Re: BusConnects Swords to City Centre Bus Corridor Scheme
Swords to Dublin City Centre

ABP case ref: 317121

BUSCONNECTS SWORDS CORE BUS CORRIDOR SCHEME

Figure 1 Example of two stage pedestrian crossings at Turnapin Lane

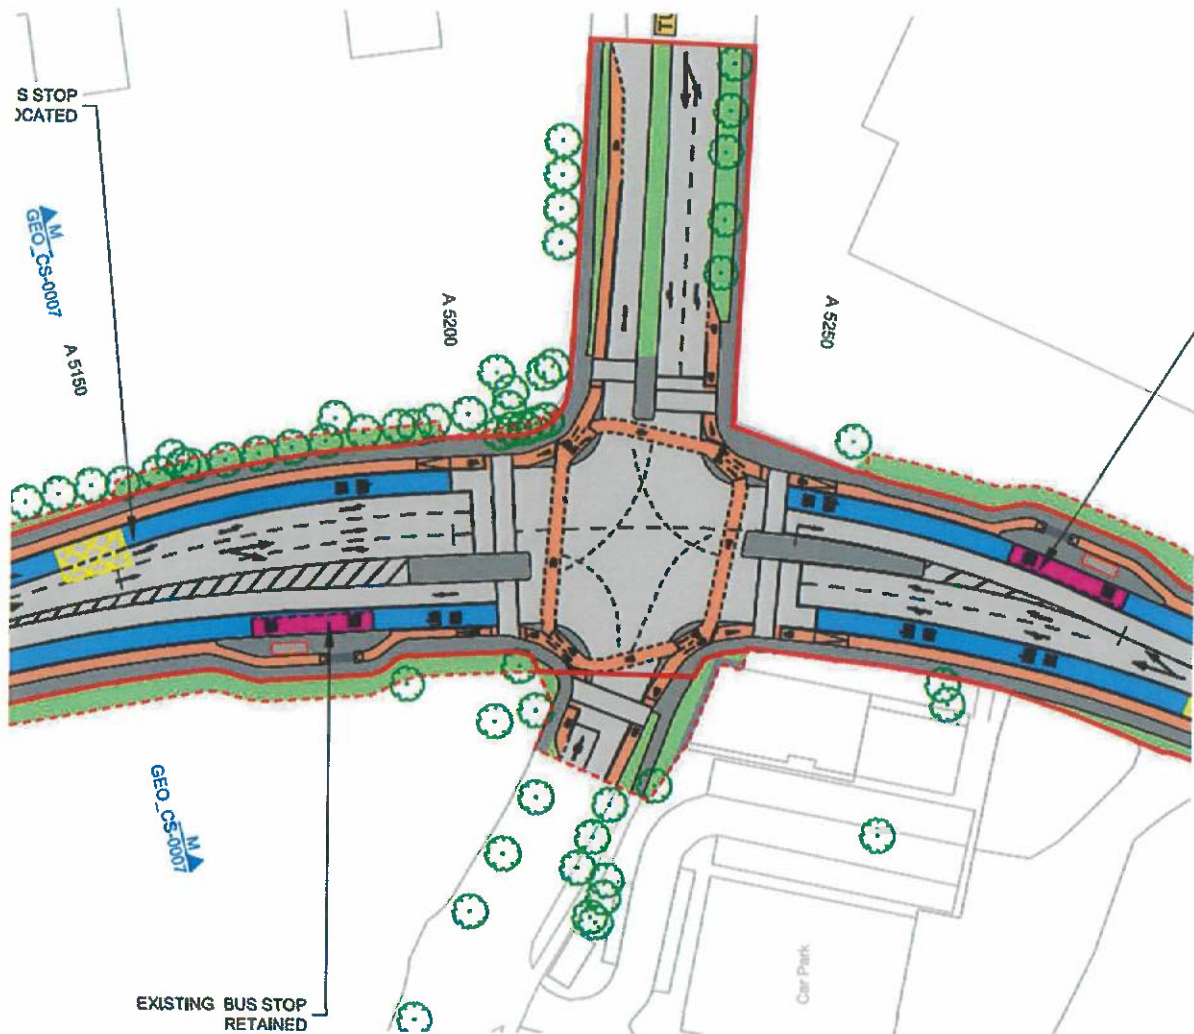
There are examples of two-stage pedestrian crossings proposed as part of this scheme. These crossings drastically increase the time required for pedestrians to navigate junctions and crossings. Section 4.4.3 Junction Design of the Design Manual for Urban Roads and Streets states that “designers should omit staggered crossings in favour of direct/single phase crossings” and Section 4.3.2 Pedestrian Crossings states that “designers should allow pedestrians to cross the street in a single, direct movement” and that “where staggered/staged crossings currently exist they should be removed as part of any major upgrade works”.

The following two-stage pedestrian crossings are clearly inconsistent with the Design Manual for Urban Roads and Streets:

- Turnapin Lane (15)
- Coolock Lane (18)
- Santry Ave (19)
- Omni Shopping Centre (20)
- Collins Ave (25)
- Griffith Ave (28)
- Clonliffe Rd (33)
- Whitworth Rd (33)
- North Circular Rd (34)
- Gardiner St Upper (34)

Figure 2 Example of a junction with a missing pedestrian crossing at Coolock Lane

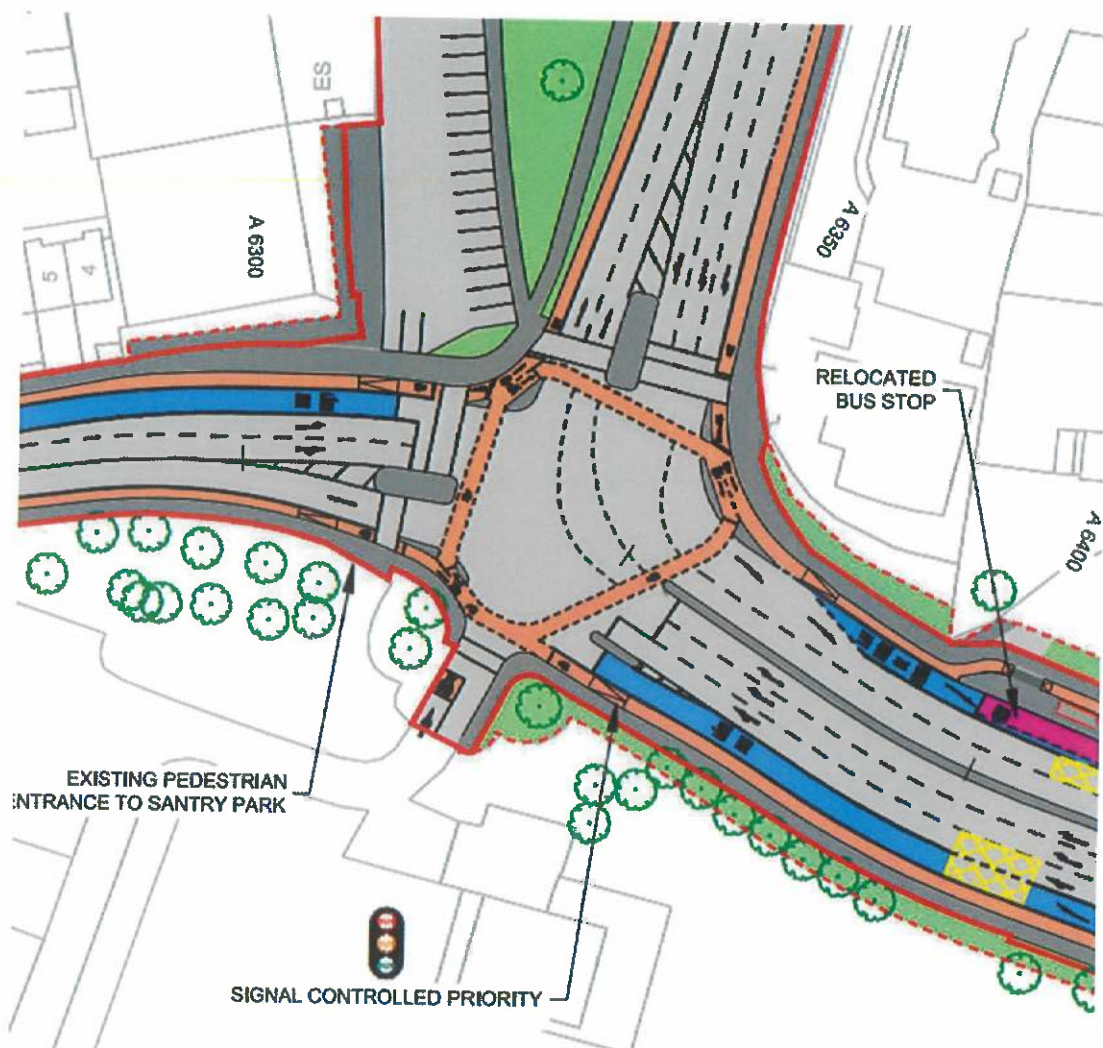
Furthermore, some three and four-way junctions are missing pedestrian crossings entirely on one or more arms. These missing crossings mean a pedestrian may need to wait for three lights — or more in the case of two-stage crossings — just to cross the street and continue their journey. Section 4.4.3 Junction Design of DMURS states that “designers should provide crossings

on all arms of a junction” and Section 4.3.2 Pedestrian Crossings states “designers should provide pedestrian crossing facilities at junctions and on each arm of the junction”.

- Kettles Lane (sheet 5)
- Cloghran Junction (6)
- Long term parking/Kealy's Pub (9)
- Old Airport Road (12)
- Quick Park (12)
- Coolock Lane (18)
- Seven Oaks (28)
- Millmount Ave (31)
- Botanic Avenue (31)
- Clonliffe Rd (33)
- Whitworth Rd (33)
- Belvedere Road (34)

Figure 5 Bus stops with inadequate bus stop islands for cycling on Swords Road

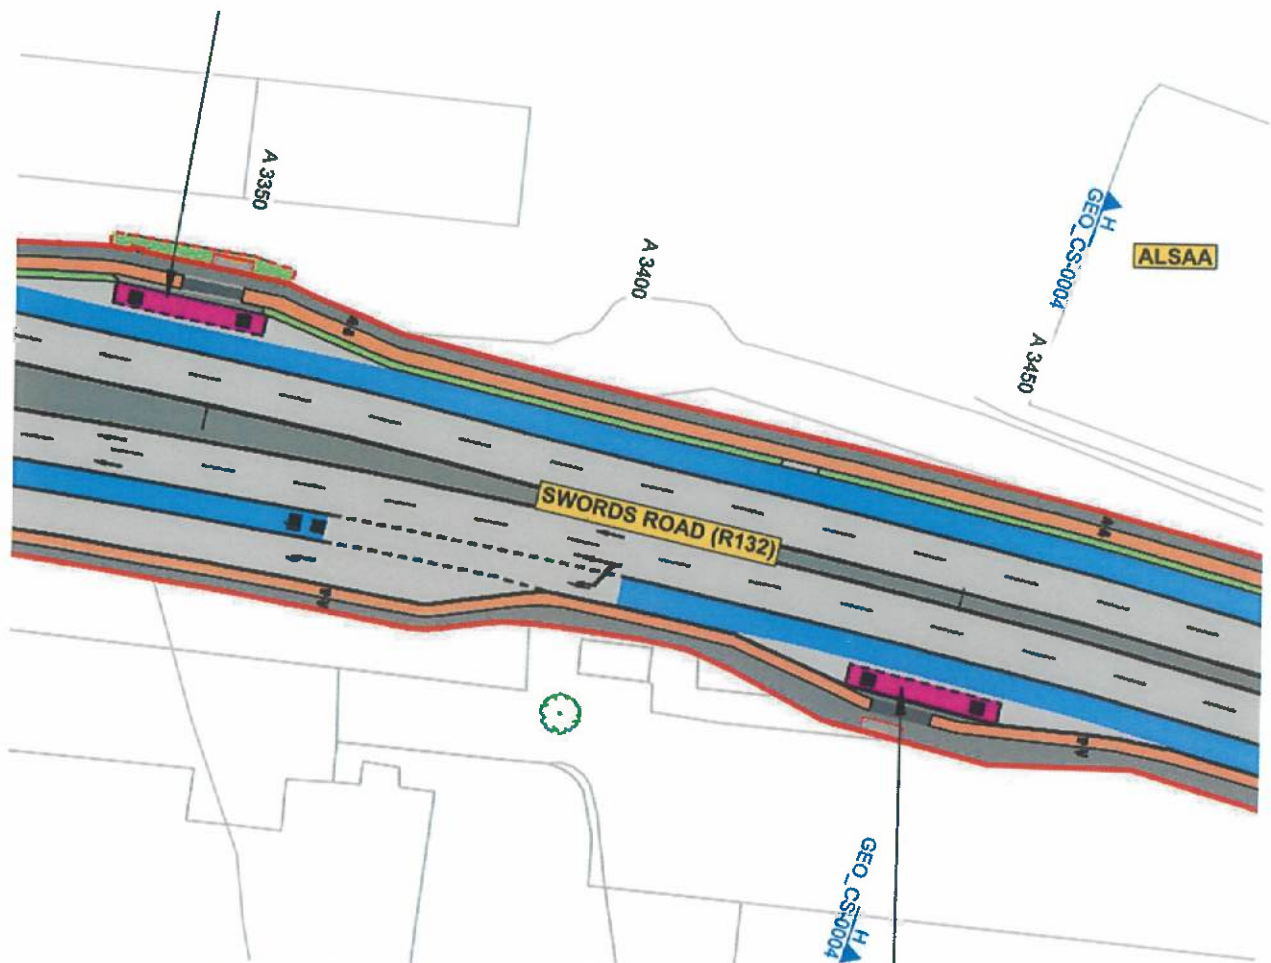
A major concern throughout the Proposed Scheme is the width of the bus stop islands that are proposed. Bus stop islands are crucial for the safety of cyclists and for encouraging all ages and abilities to use cycling infrastructure by removing conflicts between buses and bicycles. However, narrow islands place cyclists in conflict with boarding and alighting bus passengers.

Figure 6 Example of a safer island bus stop design

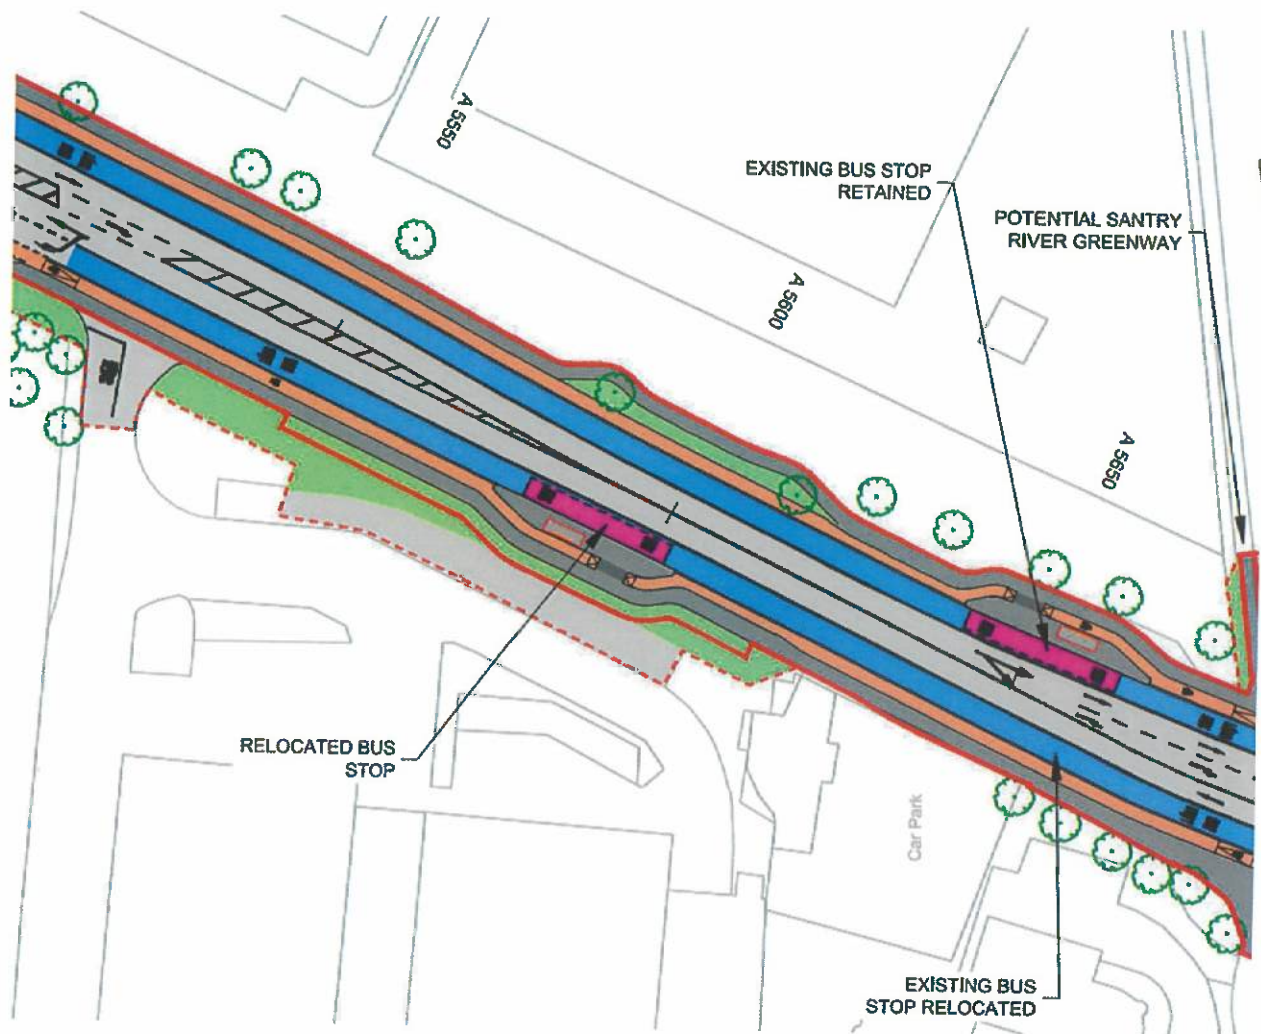
Furthermore, the design proposes routing the cycle track between the bus shelter and the road at several locations. This is not the international best practice and causes unnecessary conflict between bus passengers and cyclists. Figure 6 shows a much safer design on Swords Road where the cycle track is routed behind the bus shelter to reduce conflict.

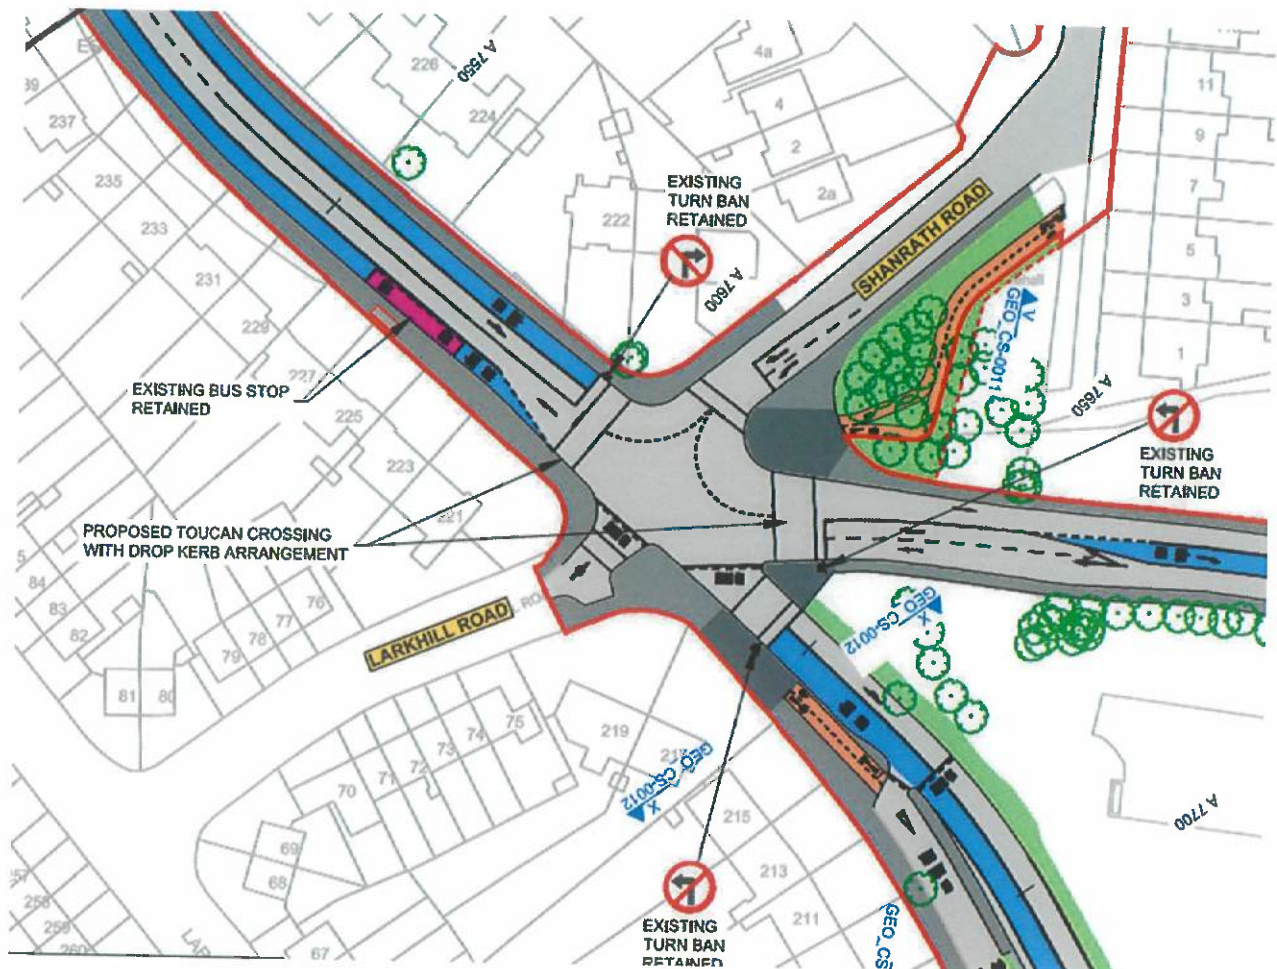
We recognise that similar commentary criticising the excessive use of shared space (between pedestrians and cyclists) has been provided by other observers, cycling advocates and disabilities groups to this application and other recent Core Bus Corridor projects. There is an inadequate and poorly designed fait-accomplis present within the subject scheme and other comparable projects, whereby a compromise to retain space for car traffic is prioritised over segregated or safe integration of active travel modes. Throughout the consultation processes it has been highlighted as a short-coming of the Bus Connects programme that international best practice or safe and innovative solutions have not been implemented or duly considered. We also would like to criticise and caution that strict adherence to out of date Irish standards will not, in combination, contribute to a safe and attractive environment for pedestrians or cyclists.

There are many junctions where the use of shared space pavement is provided where turning movements or yield areas are created for cyclists who are forced into the same spaces as pedestrians. This is significantly sub-standard given the wider scope of the Core Bus Corridor project and the potential influence it can have on the overall modal split within the Metropolitan area. This substandard design has the potential to seriously injure the vitality and usability of the public realm for the general public. Of particular concern is the conflict and danger presented by the use of shared space where it concerns those with disabilities, who may not be able to react or respond to the additional danger presented by shared space with cyclists adequately. Such additional risk can damage the reputation and general perception of the public realm and particular roads for the independent mobility of all road users.

Figure 7 Junction of South Corballis Road and Swords Road (R132)

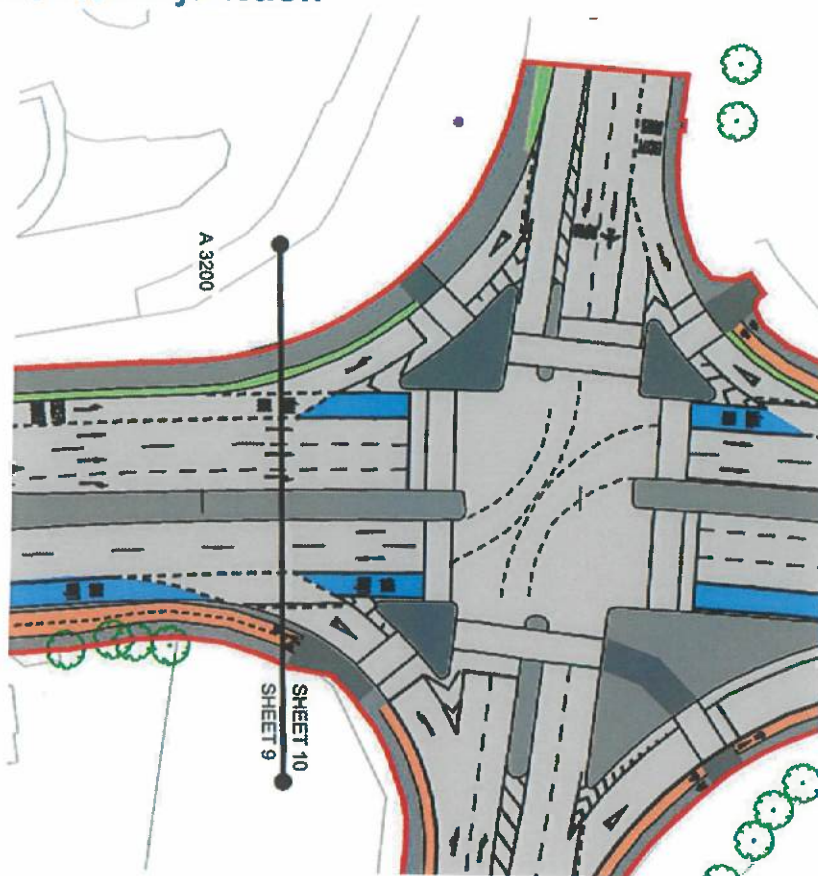
This junction is unsafe for pedestrians and cyclists and clearly does not enable sustainable modes of travel. Due to the provision slip lanes to prioritise turning car traffic, pedestrians have to make four crossings to get from one side of the road to the other and five crossings to go from one corner to the other. This could take over five minutes and is completely unacceptable. The southbound cycle lane on the western side of Swords Road ends at South Corballis Road and continues on the eastern side of Swords Road. There are 5 crossings between these points which is indirect and time-consuming.

Figure 8 Incoherent junction at Millmount Avenue

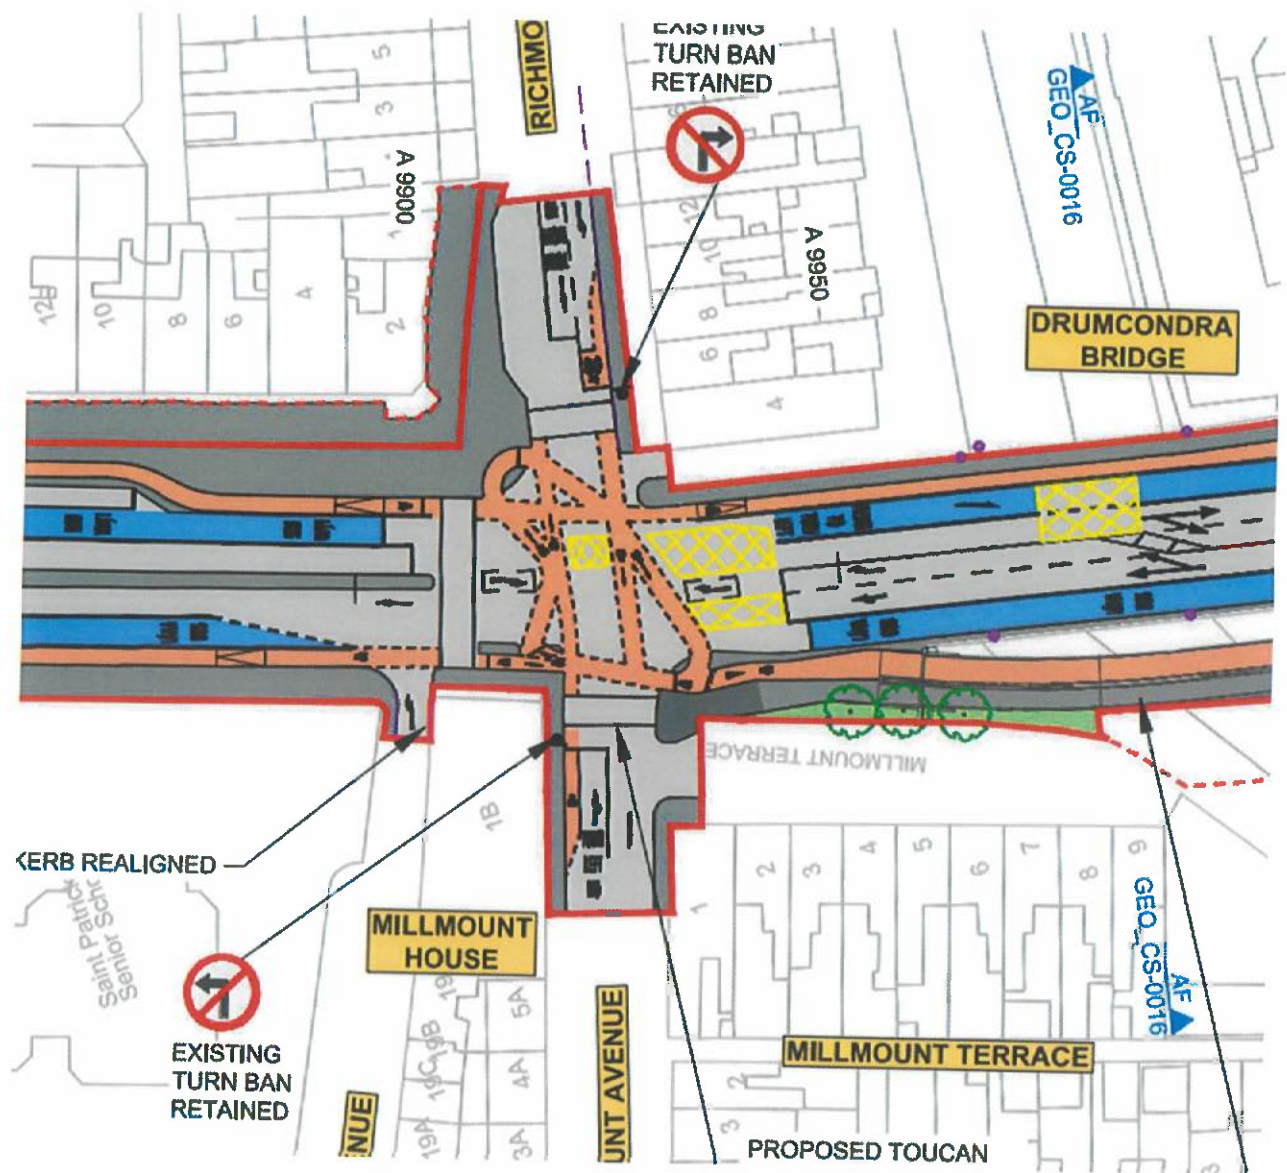
This junction needs to be completely redesigned. It's incoherent and unsafe. It's also missing a footpath on one corner as well as a pedestrian crossing on one arm. The cycling provision is confusing and overcomplicated.
